Model: Kir-C2		Date: 24-Mar-04	No.: RB121001
Subject: Important Notes for Fax Installation		Prepared by: H.Yokoyama	
From: 1st Tech. Support Sec. Service Support Dept.			
Classification:	<input type="checkbox"/> Troubleshooting	<input type="checkbox"/> Part information	<input type="checkbox"/> Action required
	<input type="checkbox"/> Mechanical	<input type="checkbox"/> Electrical	<input checked="" type="checkbox"/> Service manual revision
	<input type="checkbox"/> Paper path	<input type="checkbox"/> Transmit/receive	<input type="checkbox"/> Retrofit information
	<input type="checkbox"/> Other ()

Subject: Back of of directory information		Prepared by: H.Yokoyama	
From: 1st Tech. Support Sec. Service Support Dept.			
Classification:	<input type="checkbox"/> Troubleshooting	<input type="checkbox"/> Part information	<input type="checkbox"/> Action required
	<input type="checkbox"/> Mechanical	<input type="checkbox"/> Electrical	<input checked="" type="checkbox"/> Service manual revision
	<input type="checkbox"/> Paper path	<input type="checkbox"/> Transmit/receive	<input type="checkbox"/> Retrofit information
	<input type="checkbox"/> Other ()

Model: Kir-C2 (Paper Bank)		Date: 1-Jun

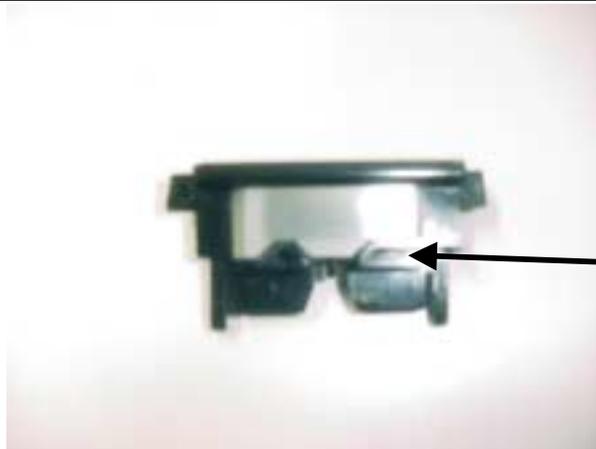
As mentioned above, all defective friction pads were made from Cav 2.

Cav number (1 or 2) is visible here.
 Cav 1: Normal
Cav 2: May be defective

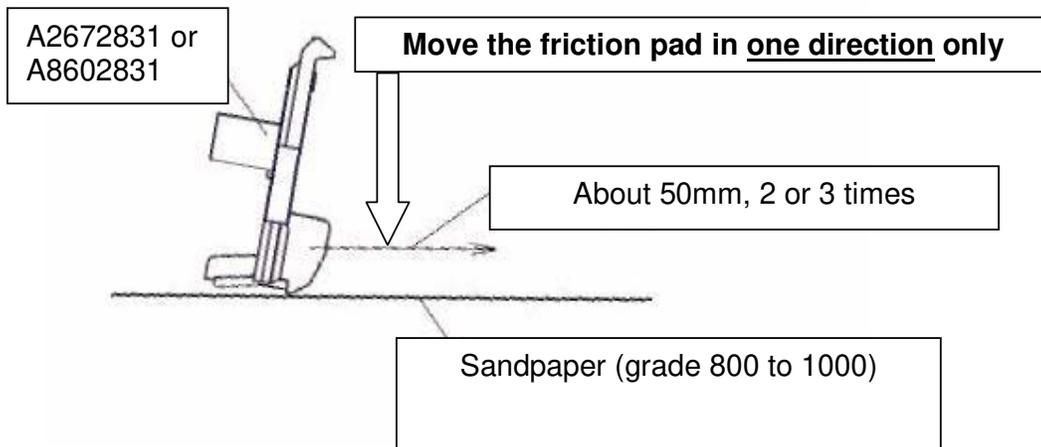
2. If it is suspected that the non-feed is caused by a defective friction pad, please try the following:

- (1) Replace the friction pad.

- (2) Remove the burr with grade 800 to 1000 sandpaper

Rub the friction pad along a 50mm length of the surface of the sandpaper as shown below, two or three times **in one direction only** (do not move the pad back and forth). This is essential to ensure that the paper is fed smoothly.

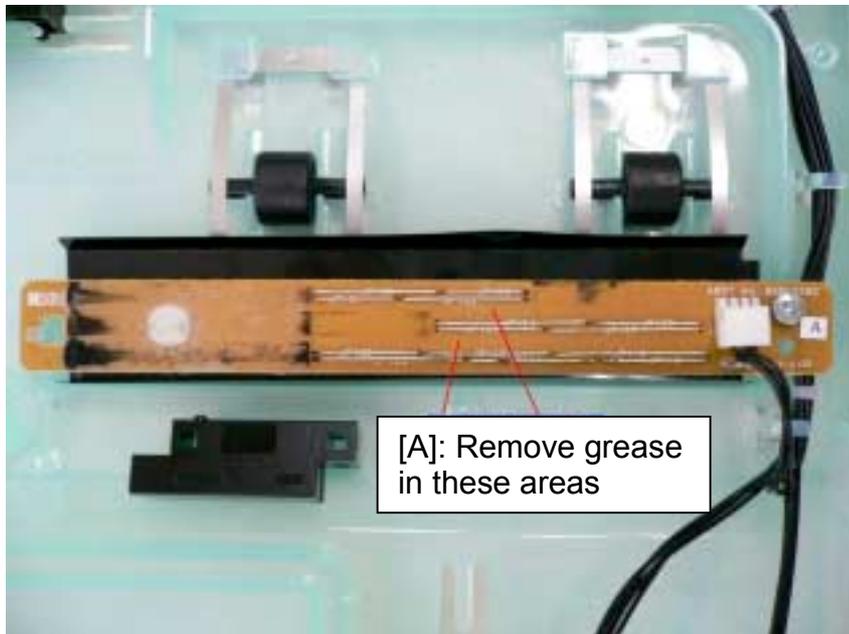
Grease sticks to the flat areas [A] on the paper size sensor board (P/N B3865550), and this interferes with the connection between the thin bars on the board and the electrode plate (P/N A8594663).

Note: The connection between the thin bars and electrode plate tells the machine the paper size. The grease is used to increase conductivity between these parts.

Fixing the Side Fence in Place

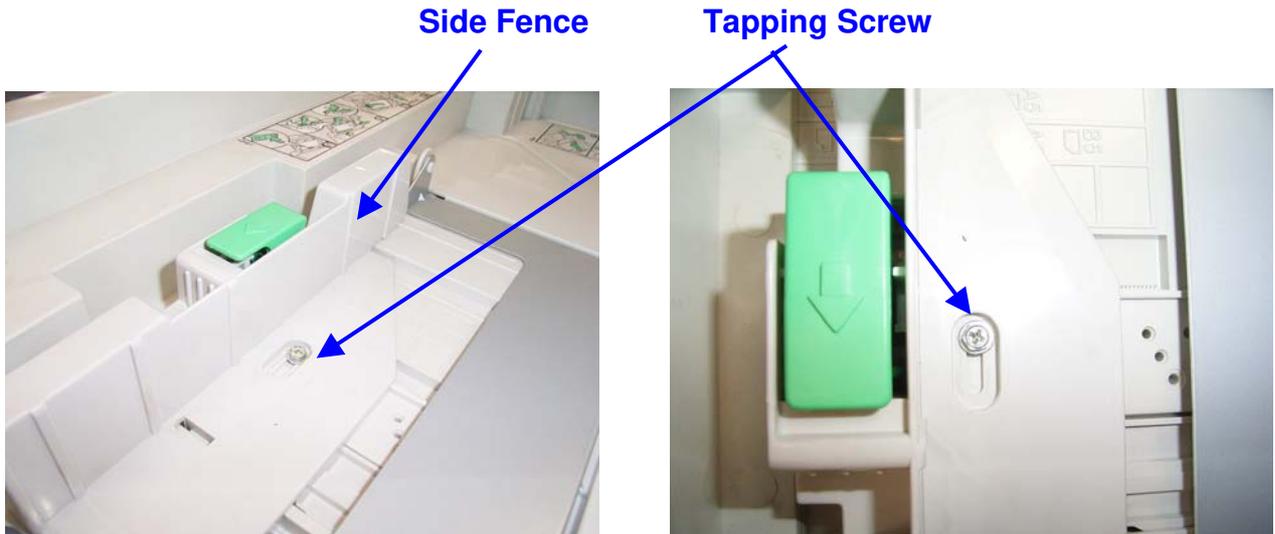
- Please inform the customer that once the side fence and the end fence are secured in place, 1) the paper size cannot be changed (until the next service visit), and 2) moving the fixed fence by force may damage the fence and/or tray base.

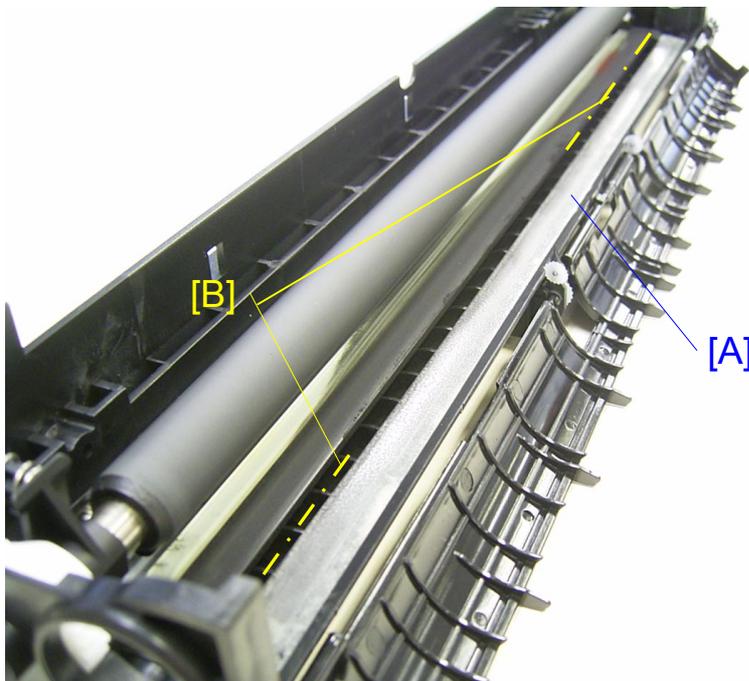
Make sure to do the following to prevent damage to the Mylar [A] and OPC:

1. When you replace the OPC together with the upper PCU case (B1212253), **be very careful so that the Mylar [A] is not damaged. Handle the OPC and the Upper PCU Case very gently.**
2. When you replace only the upper PCU case (B1212253), put some toner on the surface of the Mylar [B] that touches the OPC (operator side and non-operator side).

Note: This will decrease the friction between the Mylar and OPC and prevent damage to these parts.
